AGENDA
PLANNING AND ZONING COMMISSION MEETING
CITY OF CREVE COEUR, MISSOURI
MONDAY, JUNE 7, 2021

APPLICATION TO PLANNING AND ZONING COMMISSION
#21-018: A CONDITIONAL USE PERMIT FOR A 3,562 SQUARE FOOT
VANTAGE CREDIT UNION BUILDING WITH DRIVE-THROUGH FACILITIES
AT 611 N. LINDBERGH BOULEVARD

#21-019: MINOR SITE PLAN FOR A FOR A SIX-FOOT TALL SIGHT-PROOF WOOD FENCE WITHIN THE FRONT-YARD SETBACK ALONG LADUE ROAD FOR THE PROPERTY ADDRESSED AS 12435 ROYAL MANOR DRIVE

Figure 5: Proposed Landscape Plan

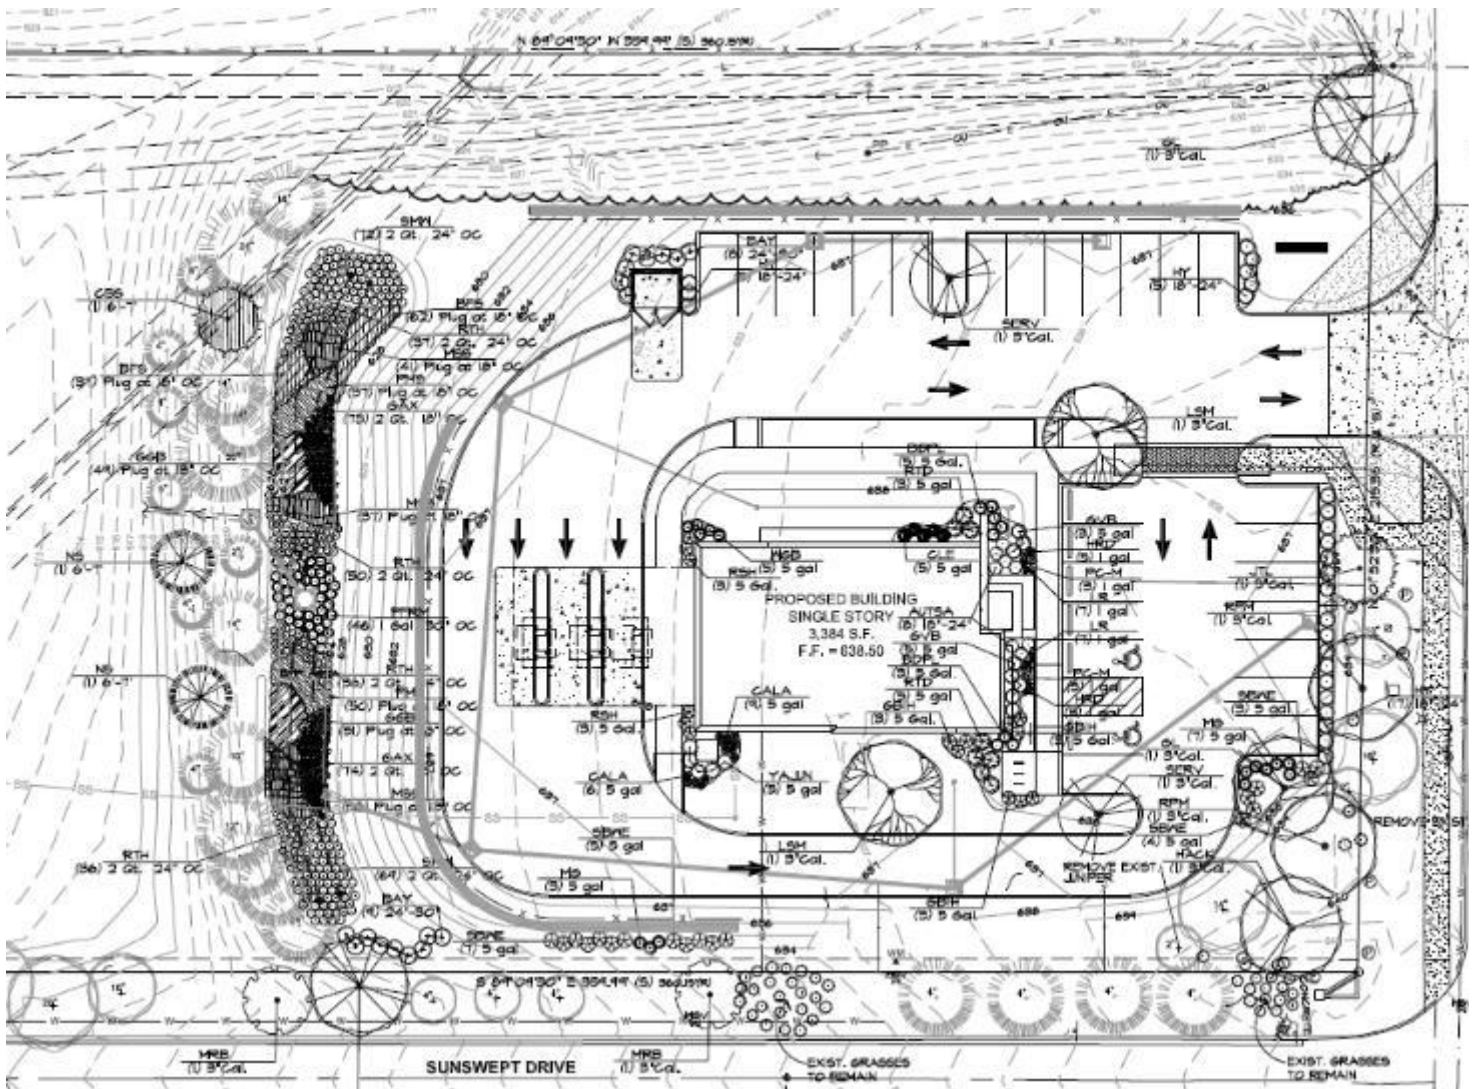
The landscape plan indicates that of the 21,780 square feet of parking lot paved area, 62.23 square feet of interior landscaped area is required, and 4,156 square feet of interior landscaped area adjacent to the building is provided. The plans indicate that the lineal frontage along Sunswept is 359.99 feet, and that 12 trees are required, 10 trees are on site, and 2 new ones are provided. The lineal frontage along N. Lindbergh is 215.36, with 8 required trees. Two are being retained, and 6 new trees are provided, in a variety of 7 types of trees. The landscape plan and the site development plan indicate that an

underground irrigation system will be provided, as required under Section 405.540(F)(10). Landscaping is provided to buffer the development from the adjoining residents, and a hedge is provided along the row of parking along N. Lindbergh Boulevard. Therefore, the Landscape Plan appears to meet with the requirements of the Zoning Ordinance. As mentioned above the building site sits approximately 26 feet above the residential properties to the west. The Commission should discuss if a sight-proof fence is also needed or if additional plantings are needed on the south side of the property adjacent to Sunswept Drive.

Figure 9: Close-up of the site plan showing retaining wall to be an earth-tone color to match building, and the 42" fence at top of back of wall.

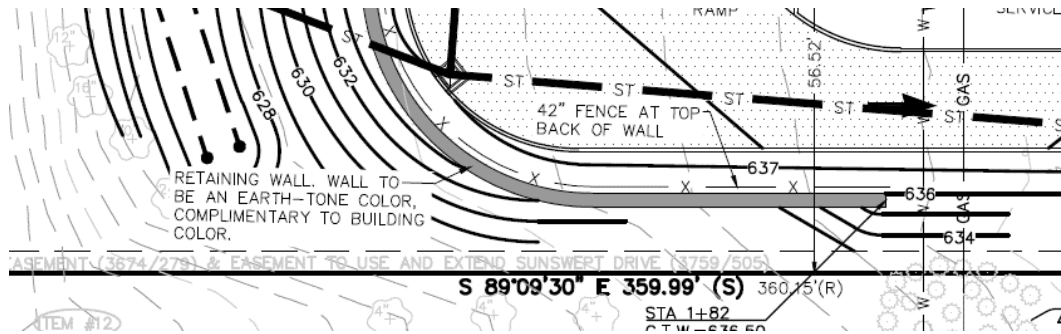
There is a 42-inch-tall safety barrier fence proposed between the retaining wall and drive aisle. A public comment received (attached) did ask for landscaping and a fence for the headlight screening. As discussed previously, there is a significant amount of landscaping along the west side of the site. Most of the existing trees will remain and new plantings are proposed. The south side of the site adjacent to Sunswept Drive is proposed to have new street trees (outside of their property) and shrubs adjacent to the retaining wall. The plantings in this area could be changed to reflect the addition of upright evergreens to provide more screening of the vehicles. The Commission should hear from the public and determine if additional landscaping or fencing is necessary. A detail of the safety barrier was not provided therefore Staff has included a condition that this fence shall be an open slatted black metal style. If the Commission wishes to have a more sight-proof design, then Staff would recommend a dark color material that matches the building to help it blend in with the landscaping.

Figure 13: Close-up of the lighting levels of the canopy structure.

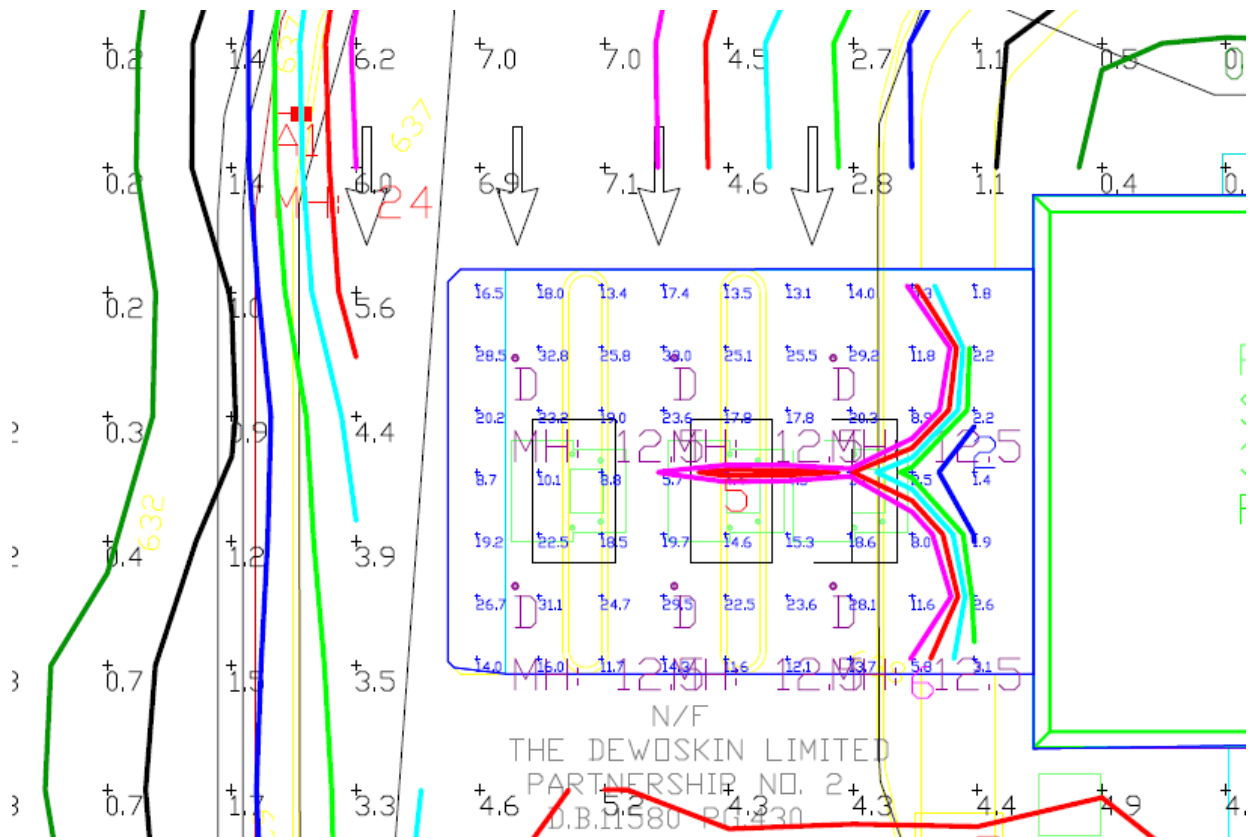
The canopy structure lighting has a maximum light level of 33 fc directly under the structure, with an average of 15.43 fc. In a prior approval for a gas station canopy the lighting levels were required to be at an average of 23.7 fc for Mobil on the Run. . The canopy structure lighting the parking and driveways have an average of 7.89 fc. The lighting levels on the west side closest to the residential uses drop off to 0.0 just beyond the drive aisle, and the landscaping.

5. All lighting shall comply with Section 405.680 Lighting and 405.810 of the Zoning Ordinance, and with the lighting levels as shown on the photometric plans for the canopy structure, as submitted on May 7, 2021.

Figure 14: Close-up of the site plan showing the new sidewalk connections to Lindbergh Blvd.

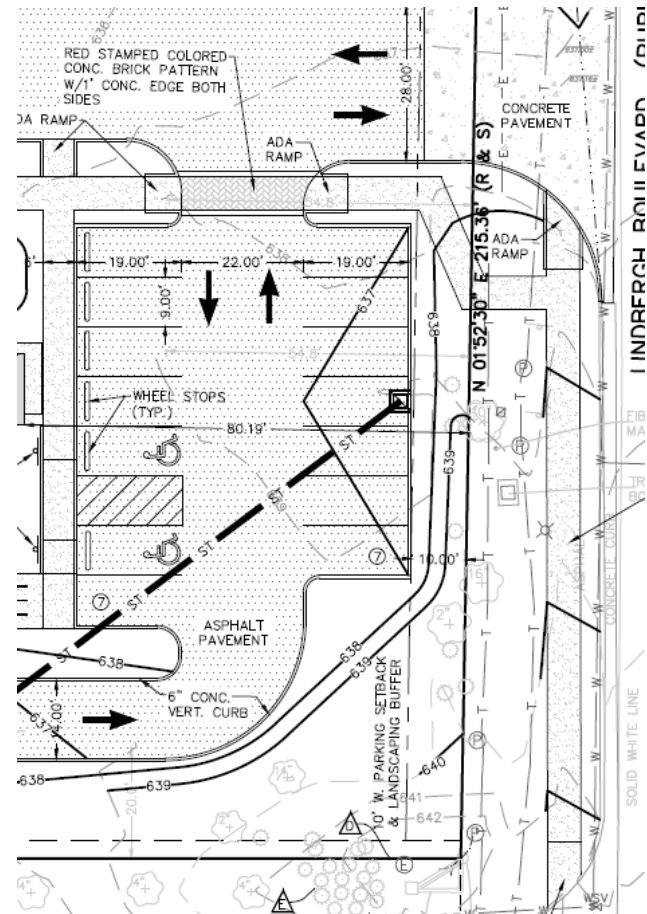
The new sidewalks were designed to comply with these regulations, with a new sidewalk along Lindbergh Boulevard south of the entrance drive. Staff did not require the sidewalk extension to north of the drive, due to the short distance and the lack of sidewalks along the Bayer properties. Further a sidewalk extension was not included along Sunswept Drive, as this is a private street.

Figure 1: Applicant's Site Plan, and fence detail.

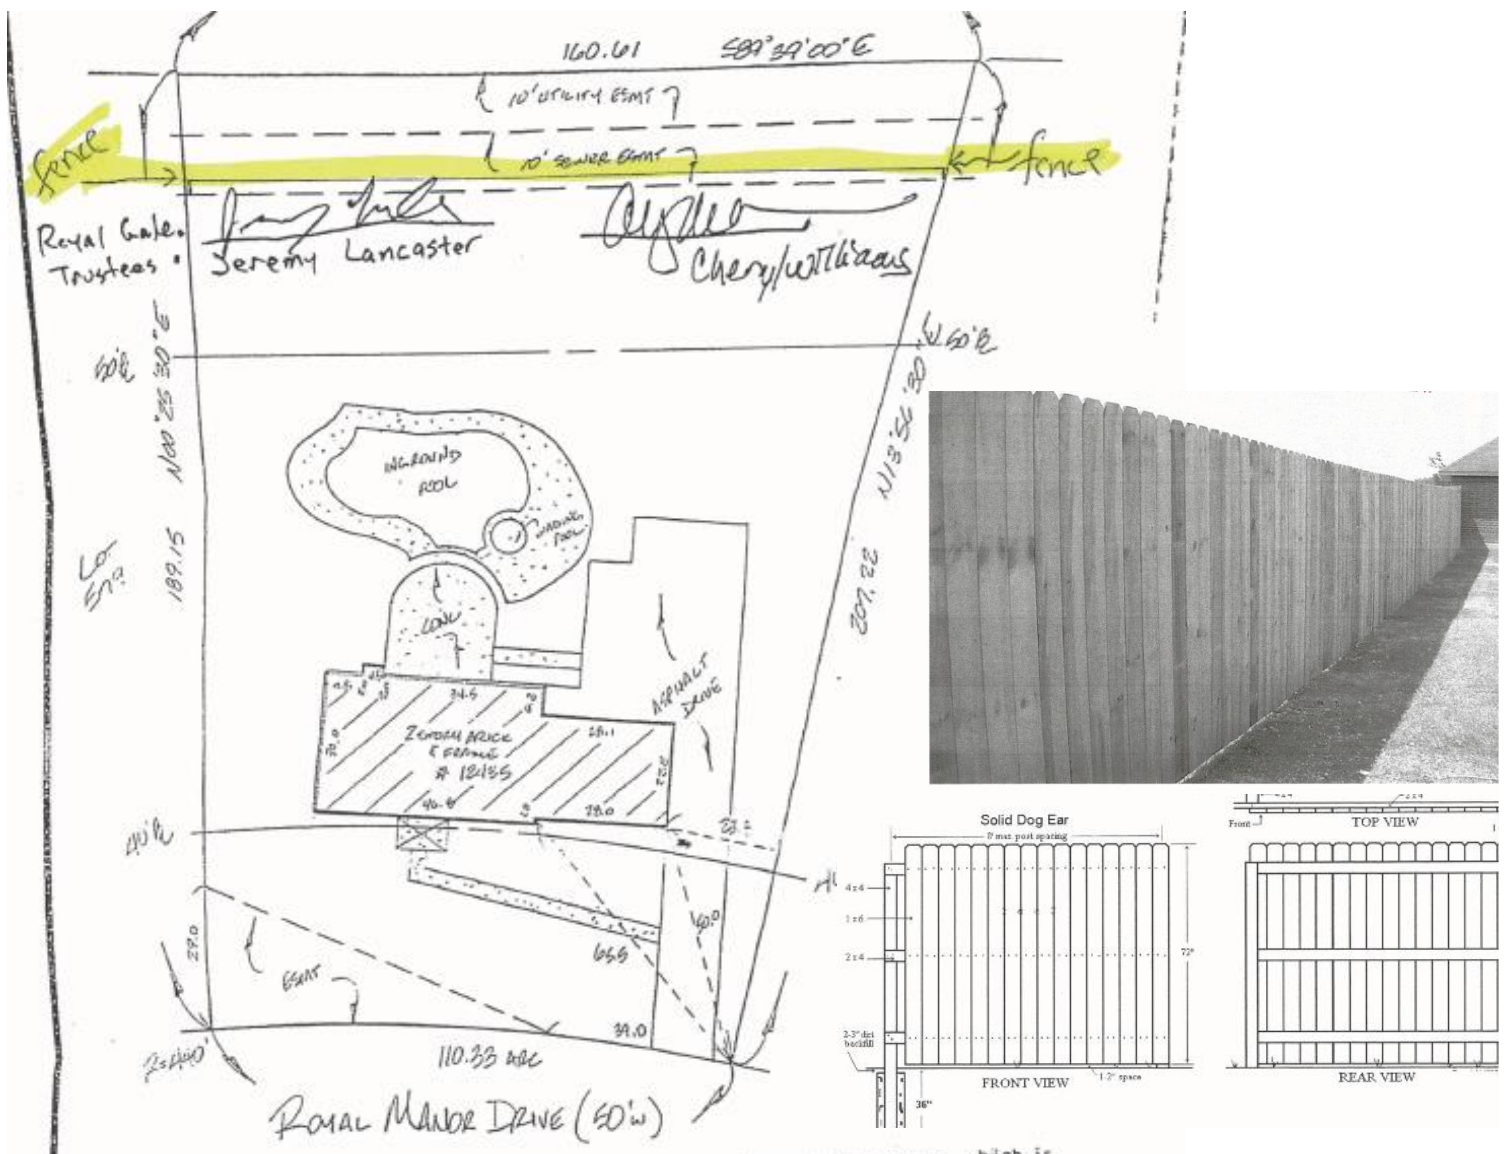
The Applicant is seeking to install a 6-foot tall, sight-proof pine wood fence, just inside the two, 10-foot easements, approximately 18 feet from the rear property line, within the area equivalent to the front-yard setback to provide privacy from the street and walking traffic along the bike and pedestrian pathway along Ladue Road. The application does not indicate whether the support posts of the fence would be interior to the yard. Further, the fence does not fully enclose the yard, rather it would be a free-standing structure along the rear of the property.
